Re: Case File No. DR-044-25 Sky Harbour Hangars, revisions in response to April 8, 2026 Planning Commission hearing

A. Revisions

Comparison of Previous and Revised Proposal

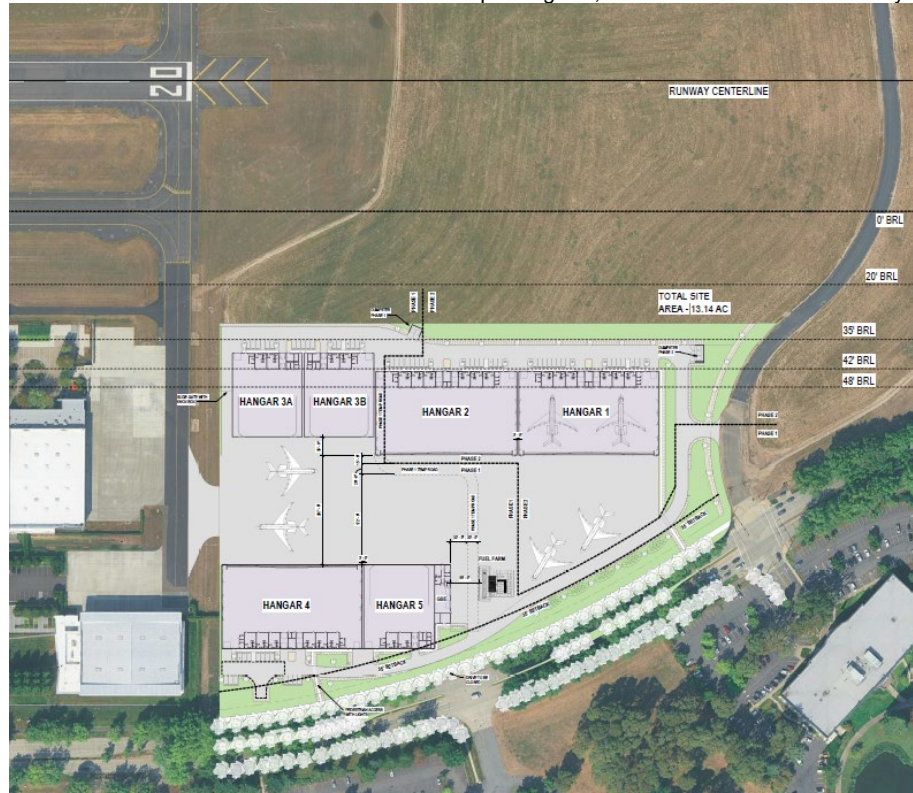
All vehicle paving and buildings have been relocated outside of the 35-foot front yard setback. Thus, Adjustments are no longer required. The number of hangars has been increased from 6 to 7, **though the total hangar square footage has been reduced by 9,385 square feet.**

2. There are now 7 individual hangar buildings instead of 6. However, this is due to Hangar 2 changing from one larger hangar to two smaller hangars (now Hangars 2a and 2b), identical to the configuration of Hangars 3a and 3b. This results in two large hangars and five smaller hangars, instead of three large hangars and three smaller hangars.

3. The total hangar square footage is reduced due to a reduction in the size of Hangar 5. Hangar 5 is reduced in area from 21,440 square feet to 12,055 square feet. Interior accessory offices and customer waiting areas have also been eliminated from this hangar. This enables Hangar 5 to be moved entirely outside of the front building setback and to allow area for the access driveway to be entirely outside of the 35-foot front yard setback.

-
4. Hangar 5 is separated from Hangar 4. Hangar 4 has shifted north from the southern boundary lease line. This space will now be used for fire truck circulation around Hangar 4, similar to the fire truck circulation around Hangar 3b. Appropriate turning radii are provided in the revised plan. This removes the fire truck turnaround previously located within the 35-foot front yard setback.

5. The GSE (Ground Support Equipment) is now adjacent to Hangar 4 instead of Hangar 5.
 6. Minor changes to parking area configuration. This was to respond to the shifted location of Hangar 5, the reduction in size to what was Hangar 2 (into 2a and 2b) and to remove all parking from the front yard setback.
